**CONTRACT DE-AC24-01OH20115, RESPONSE TO COMMENTS FOR THE
ADVANCED WASTEWATER TREATMENT FACILITY IMPLEMENTATION PLAN
FOR ABOVE-GRADE DECONTAMINATION AND DISMANTLEMENT**

**AWWT COMPLEX IMPLEMENTATION PLAN FOR ABOVE-GRADE D&D
FERNALD CLOSURE PROJECT RESPONSE TO USEPA COMMENTS**

DOCUMENT NUMBER 1789-PL-0007 (REV. 0) PCN1

FIGURE 1-1 Advanced Wastewater Treatment Complex PCN1

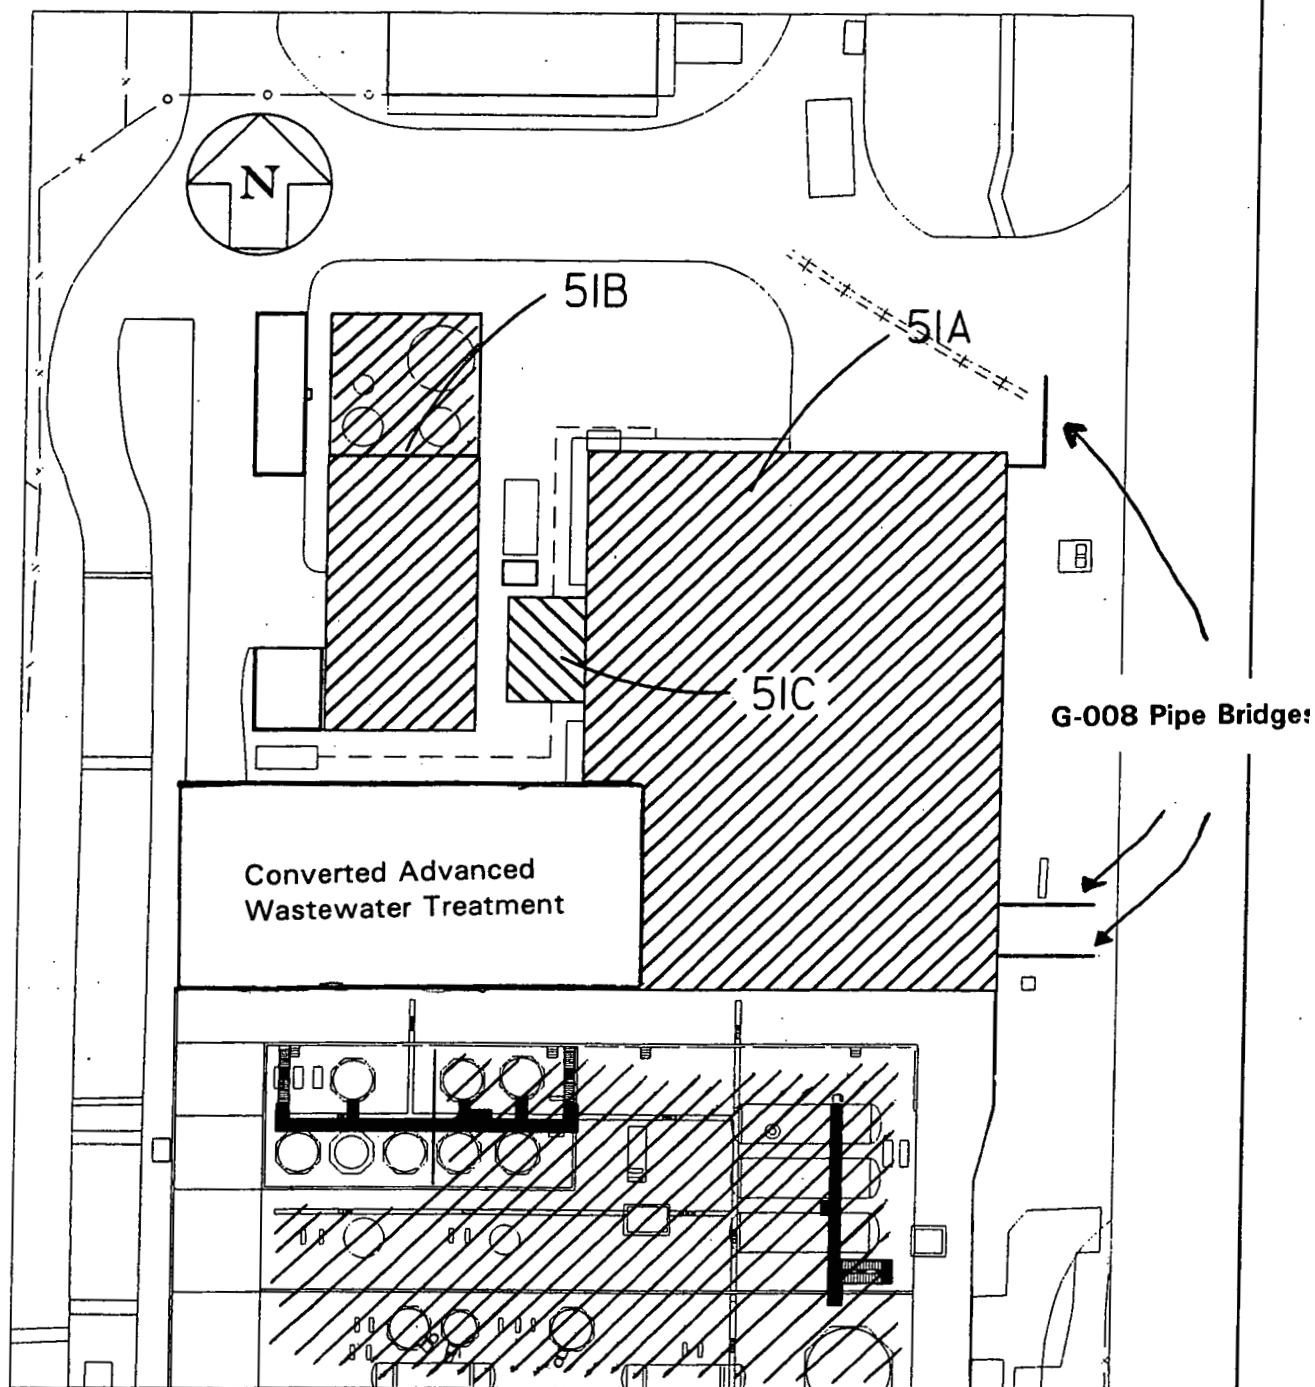
Comment: The text states that Components 51A, 51B, 51C and G-008 are included in the AWWT Complex Decontamination and Dismantlement project. Figure 1-1 on page 4 does not show Component G-008. Figure 1-1 should be revised to show all the components.

Response: Figure 1 has been revised to identify Component G-008.

FIGURE 2-1 Air Monitoring Locations PCN1

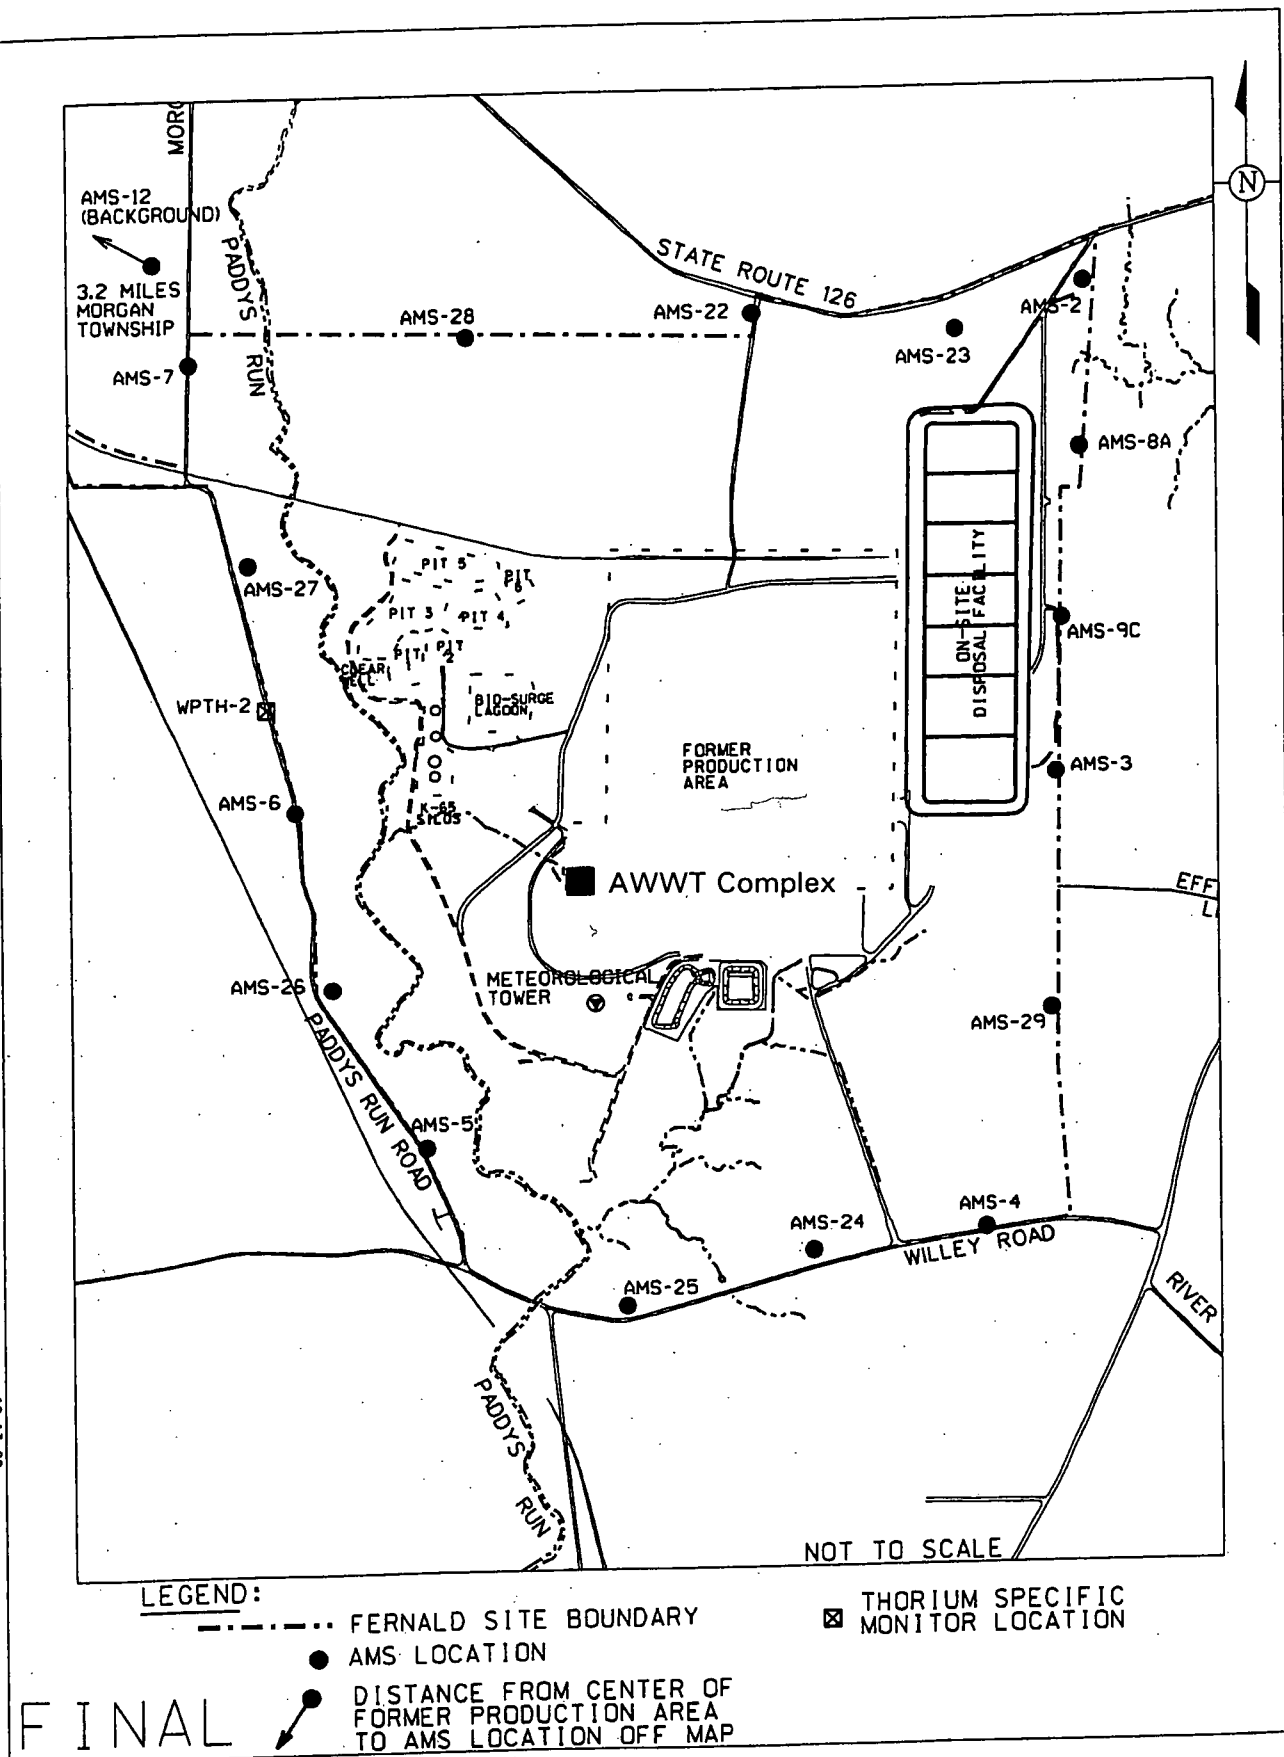
Comment: The figure shows locations of various air monitoring stations. The figure does not show the location of the AWWT Complex. The figure should be revised to include the location of the AWWT Complex.

Response: Figure 2-1 has been revised to show the location of the AWWT Complex.
